## ANN ARBOR HISTORIC DISTRICT COMMISSION

### Staff Report

**ADDRESS:** 521 Fifth Street, Application Number HDC16-283

**APPLICATION:** The applicant seeks HDC approval to remove a modern garage and replace it with a new garage with a carport in front.

521 Fifth Street (2007 Survey Photo)

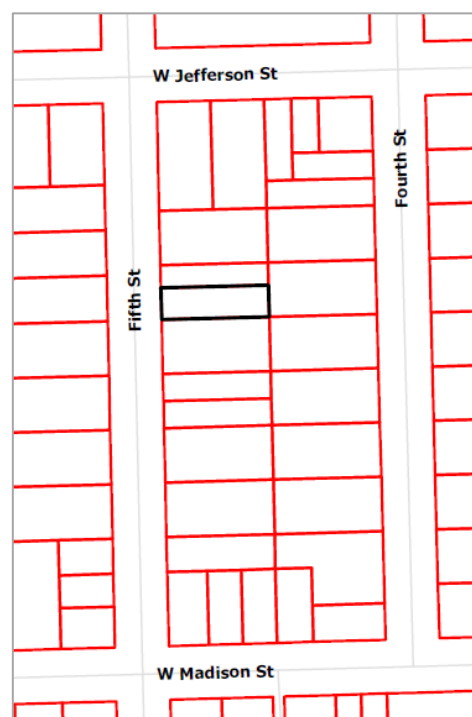
**BACKGROUND:** This 1 ¾ story gable-fronter features two over two windows, wide board eave trim, a cut stone foundation, and a small Queen Anne style entry porch. It appears in the 1894 Polk City Directory as the home of laborer G. Frederick Mack at number 33. That address does not appear in the 1891-2 directory.
